Port Stephens Council – Design Review Panel

ITEM No. 1

Date of Panel Assessment:	13 March 2025
Address of Project:	42 Donald Street NELSON BAY; 7 Church Street NELSON BAY; 5 Church Street NELSON BAY
Number of Project: (if applicable)	
Pre - DA Number:	18-2024-34-1
No. of Buildings:	One
No. of Units:	57
Declaration of Conflict of Interest:	Nil.
Attendees:	<u>Applicant</u> - Robert Hellbery – Architect - Daryl Ryan – Planner - Jon Lindsay – Fortezza Group <u>Port Stephens Council</u> - Isaac Lancaster - Mathew Egan

NORTHERN MIDDLE UNIT

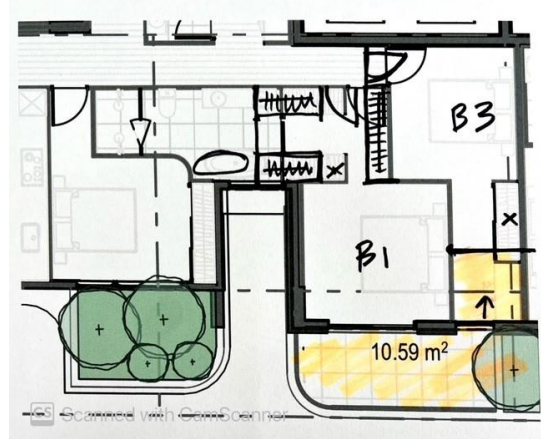
- Unit numbers should be indicated on the Architectural Plans to allow ease of documentation review.
- ‘Tunnel’ type bedrooms- (where bedrooms are recessed behind other rooms and only served by narrow windows at the end of a corridor) are not generally supported by the Panel and are not compliant with the ADG. These are currently proposed in the central North and South dwellings on floor 4 and above. Options for plan adjustments to improve these rooms were discussed during the meeting and should include removing the built in robe from the ‘tunnel’ to maximise the potential glazing and useable width, and further indenting the window to minimise length of the ‘tunnel’. A range of possible alternatives could be explored, one example is included below, sliding the Laundry in the Northern units to allow for relocation of the robe, or sliding the Walk in Robe in the Southern Units; the depth of the tunnel (“snorkel”) should be no greater than illustrated, and width no less – as this is intended to indicate a minim level of amenity to be achieved with this arrangement.
